FINAL DRAINAGE REPORT
FOR
SADDLEHORN RANCH – FILING 3

February 4, 2022
Project No. 25142.05

El Paso County PCD File No.:
SF234

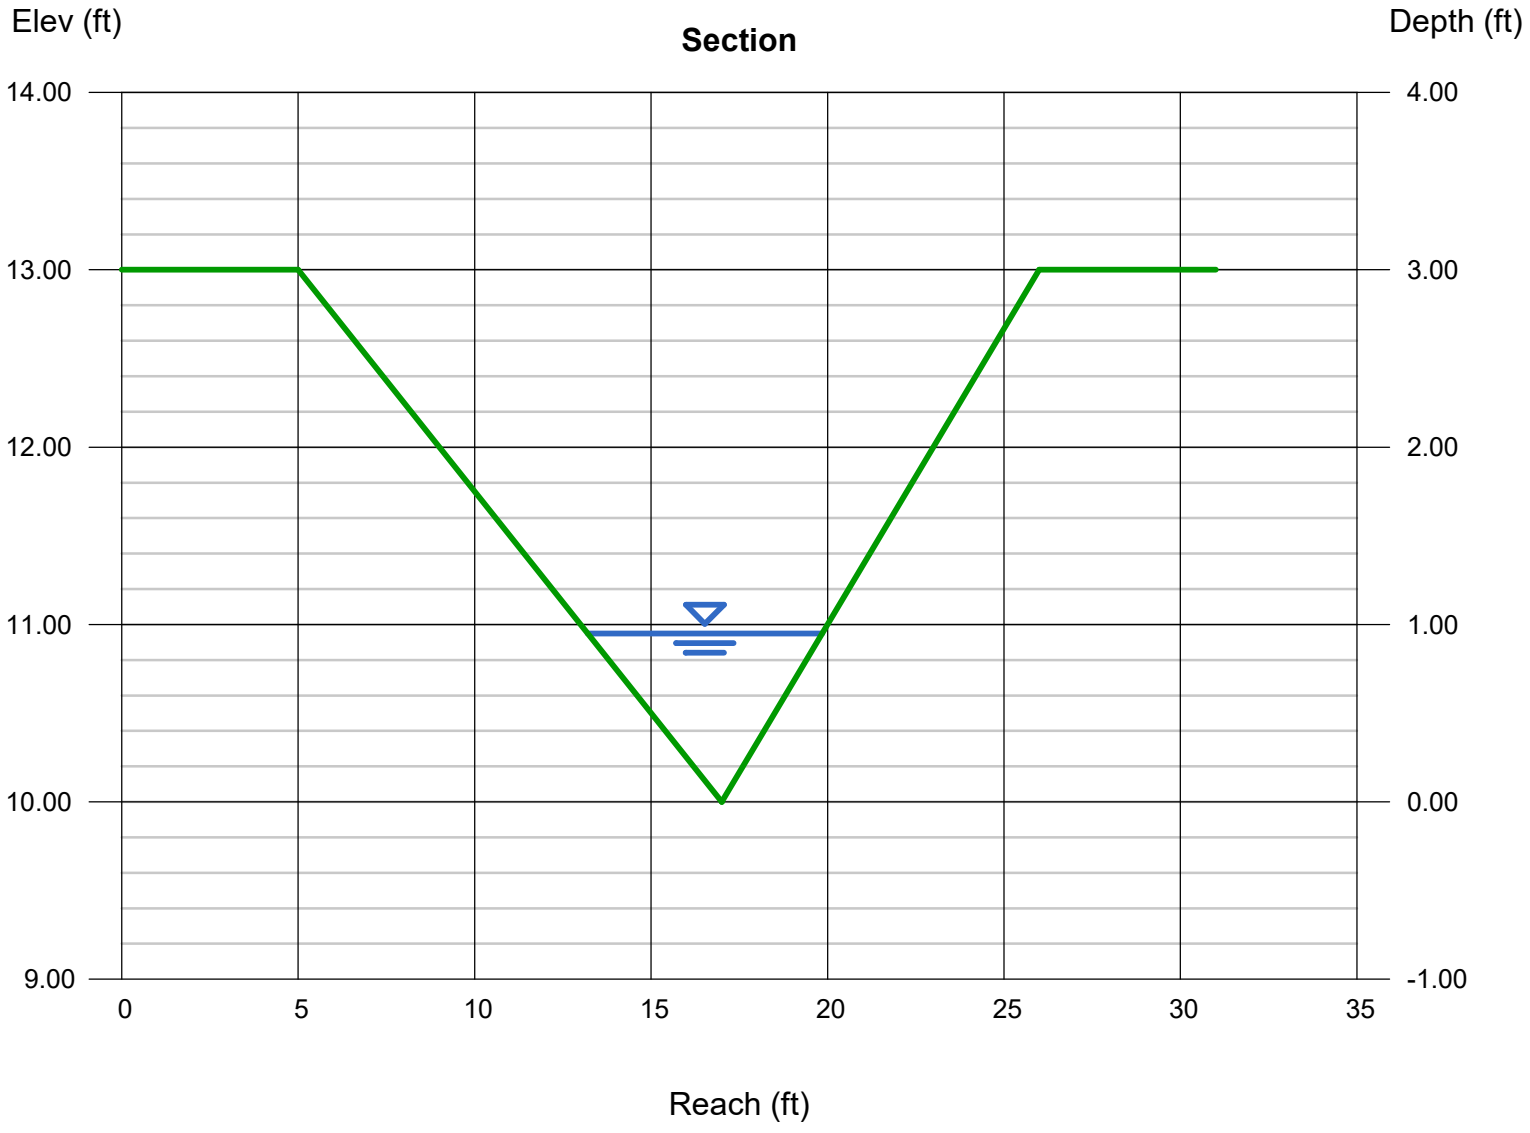
Previous comment stated FR # was over allowable. What changed in swale design to lower the FR #? From information shown, do not see anything different that would lower FR #.

Unresolved:
Slope is 2.3% per drainage map.

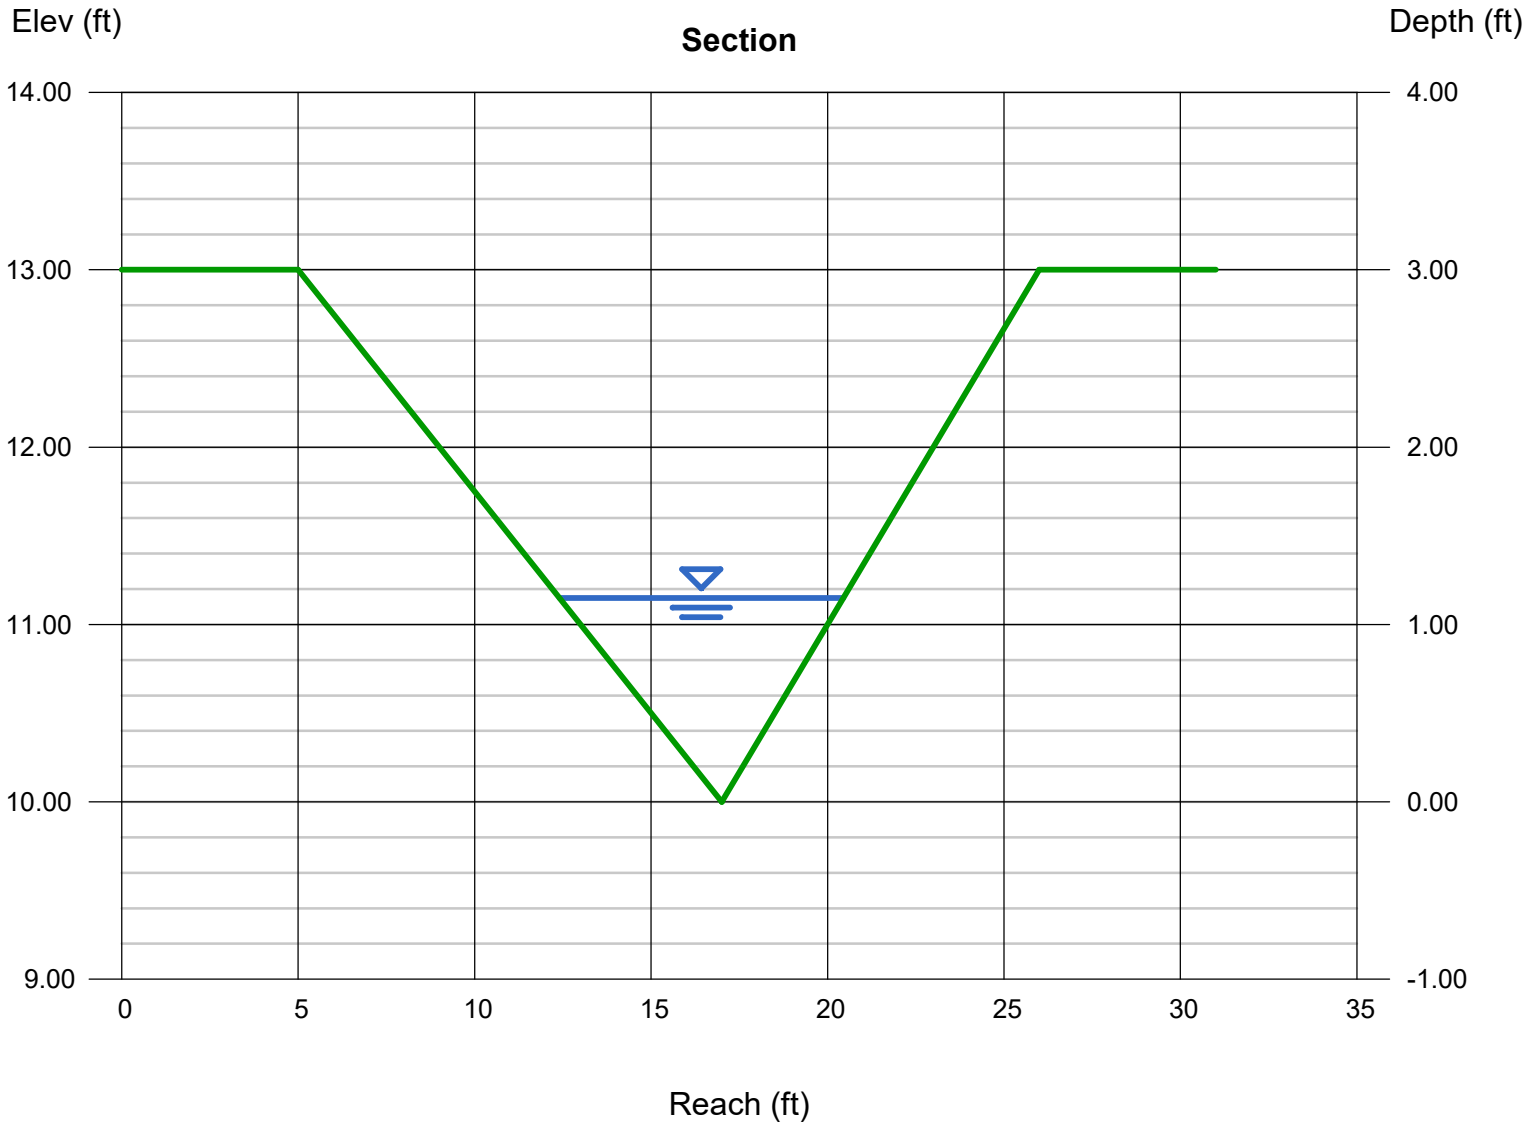
Previous comment stated FR # was over allowable. What changed in swale design to lower the FR #? From information shown, do not see anything different that would lower FR #.

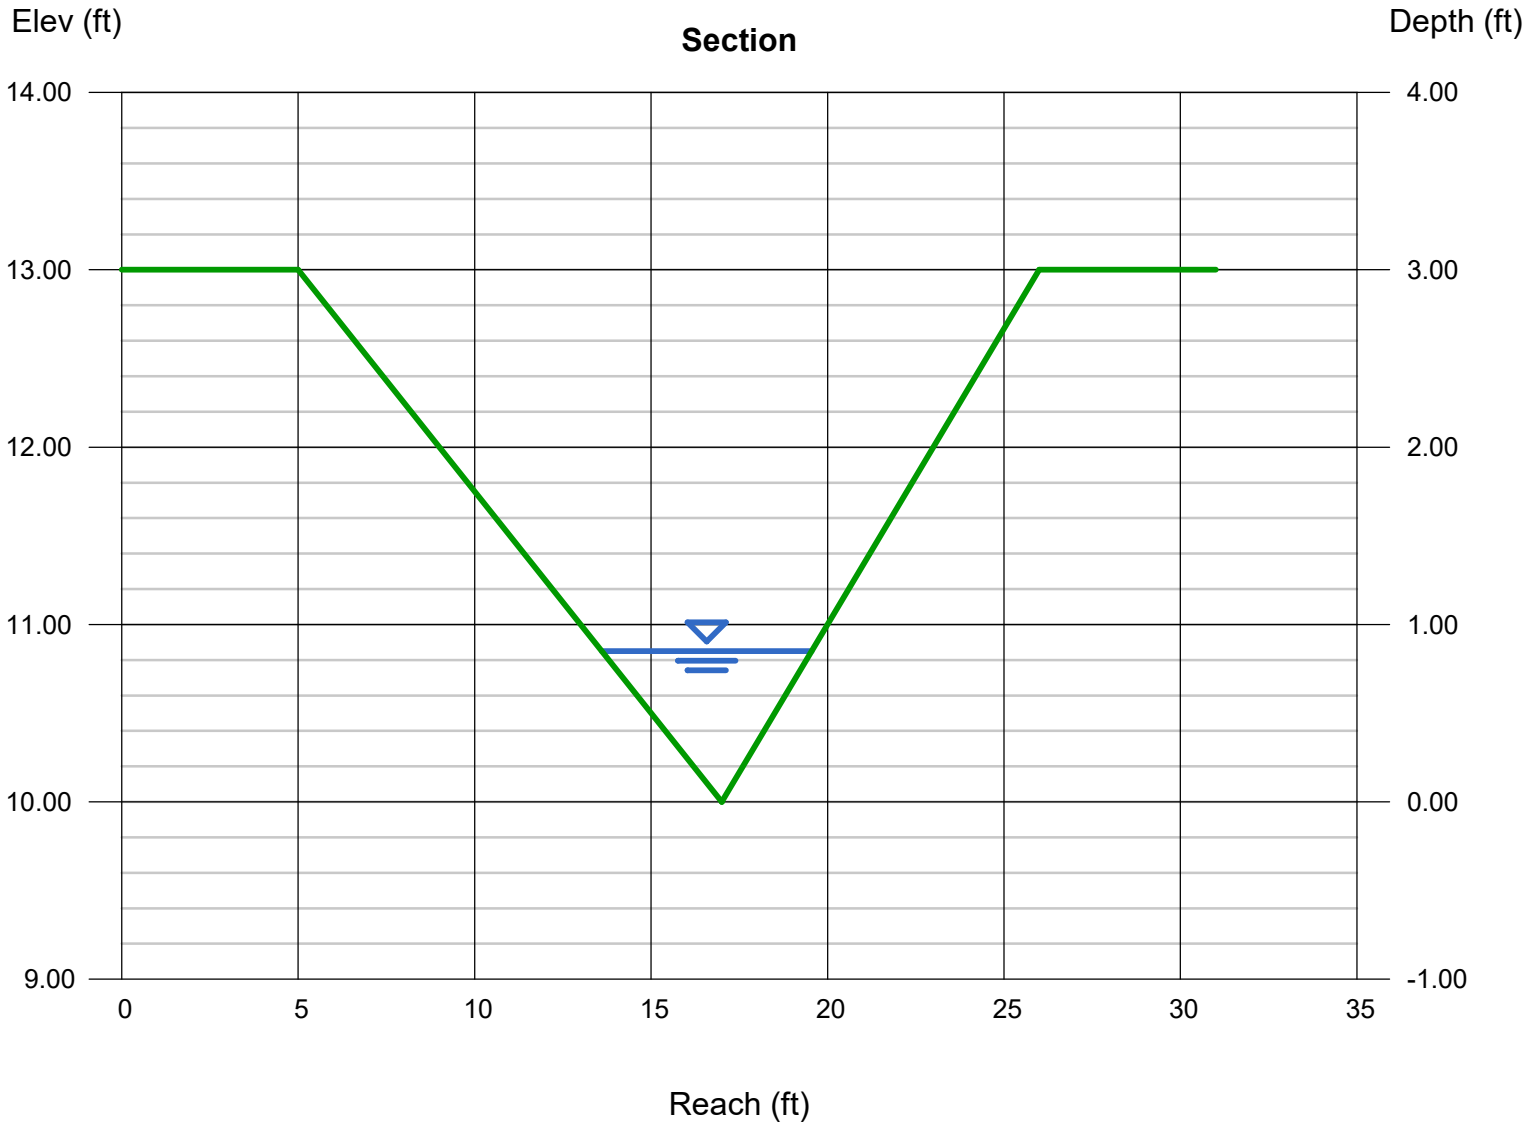
Previous comment stated FR # was over allowable. What changed in swale design to lower the FR #? From information shown, do not see anything different that would lower FR #.

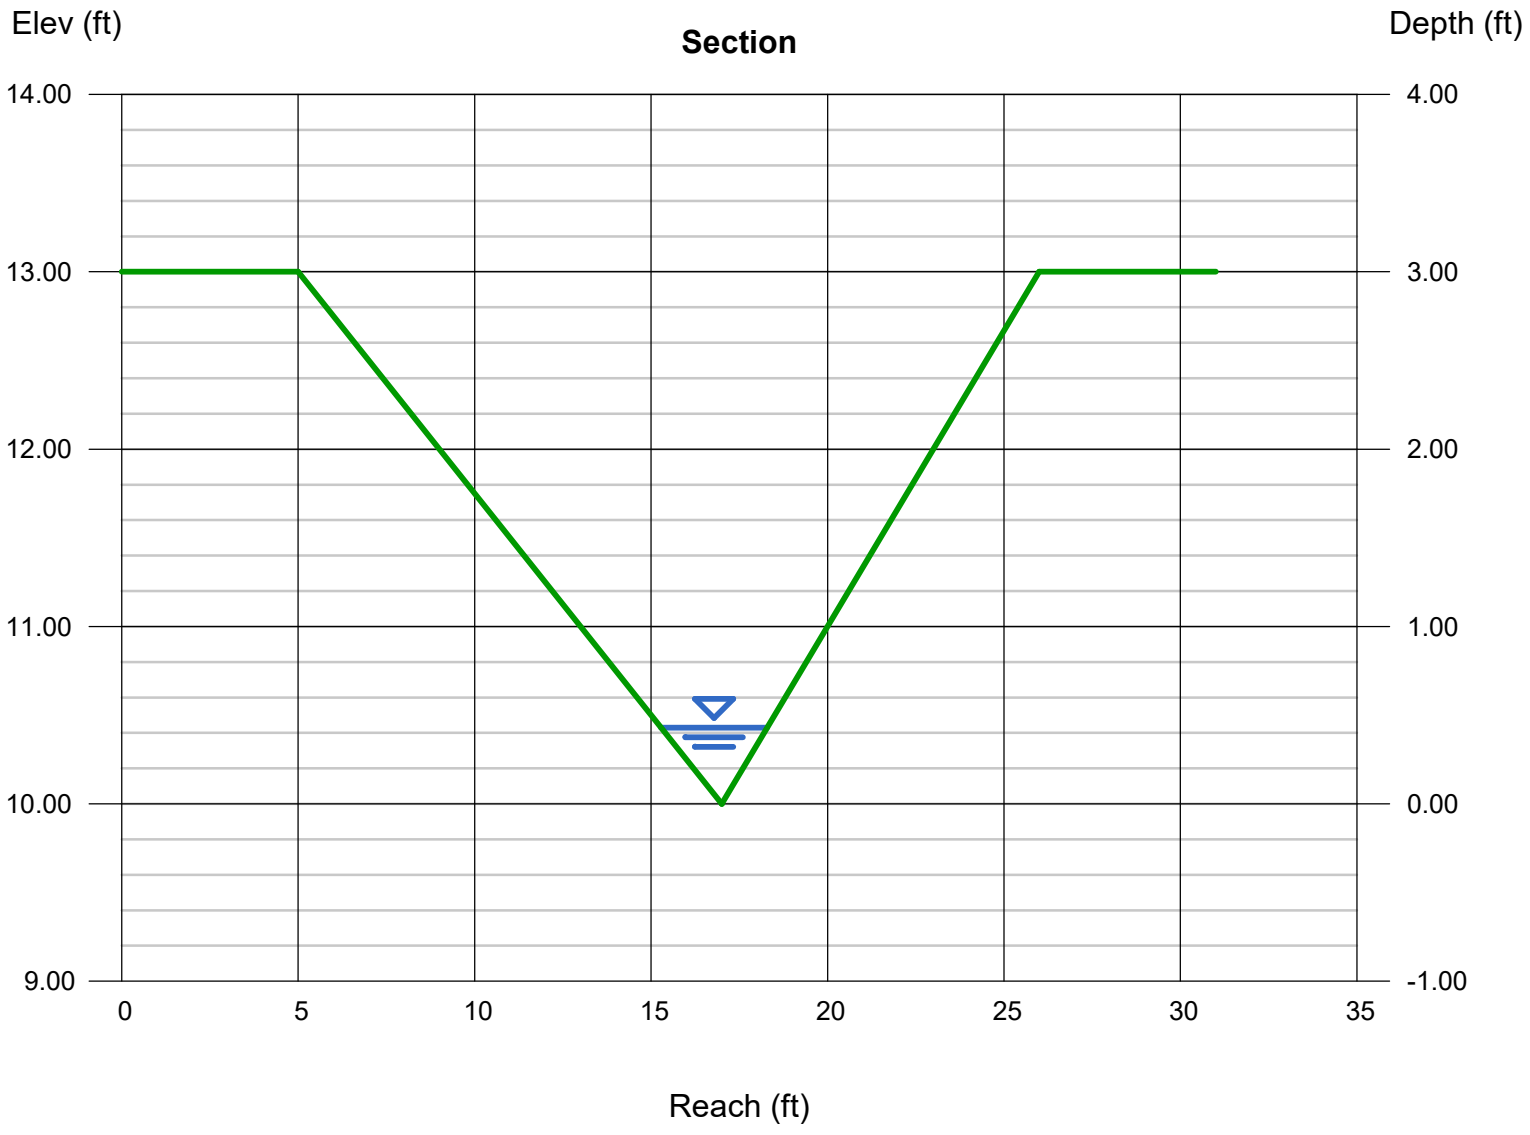
Previous comment stated FR # was over allowable. What changed in swale design to lower the FR # ? From information shown, do not see anything different that would lower FR #.

Unresolved: Slope is 2.3% per drainage map

EXISTING CONDITIONS MAP
SADDLEHORN RANCH FILING 3
JOB NO. 25142.05
1/7/22
SHEET 1 OF 1

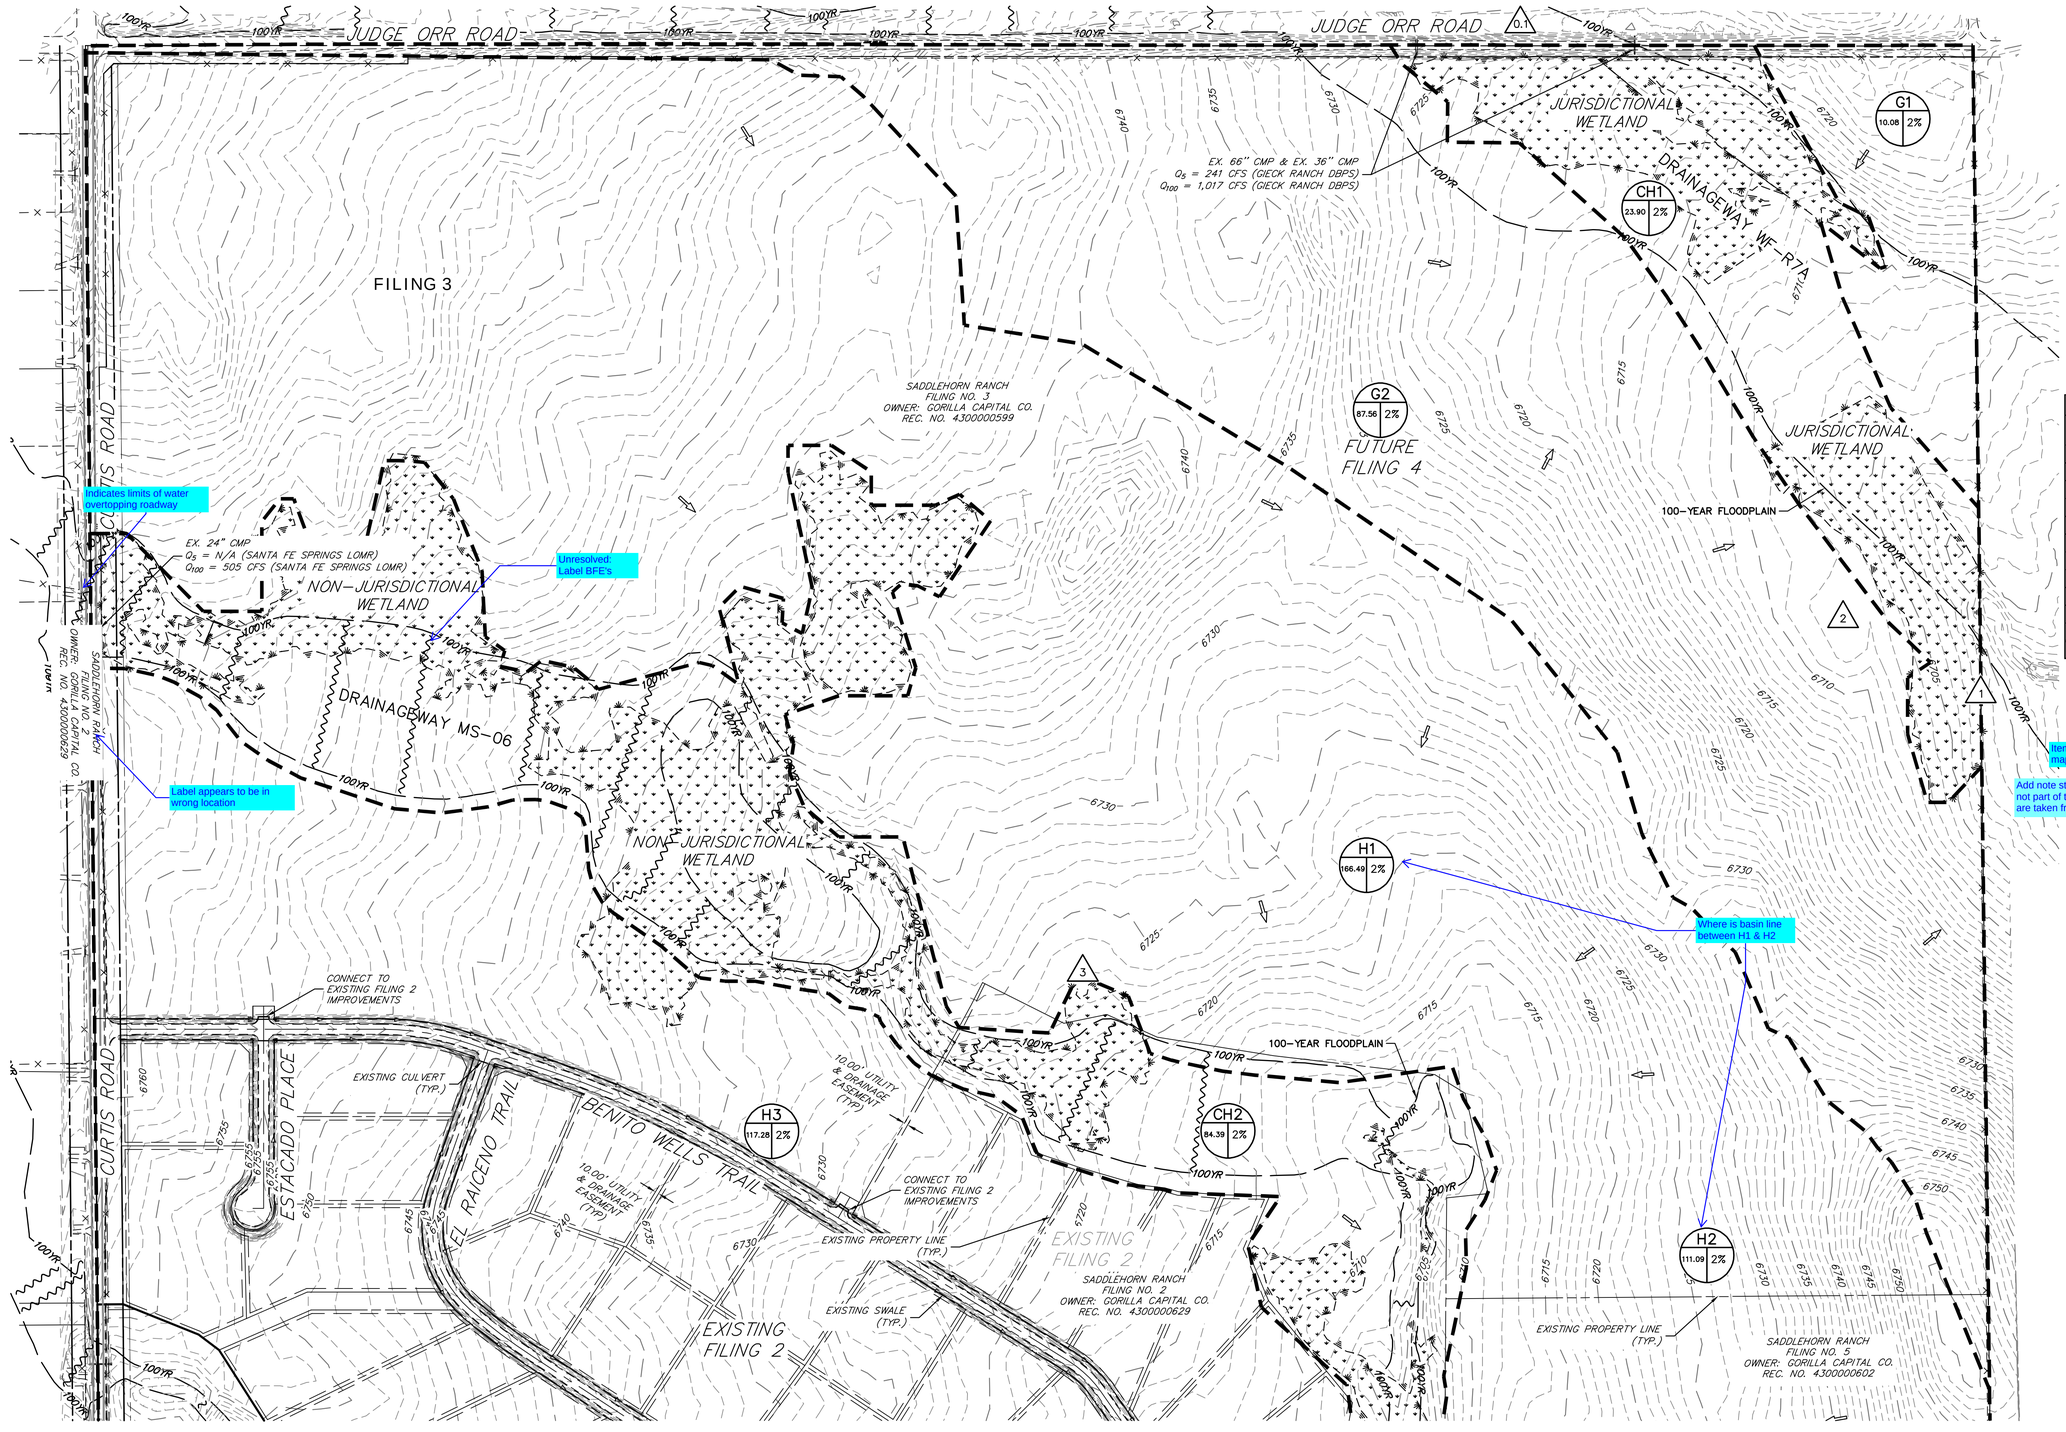
Unresolved:
Label surrounding property
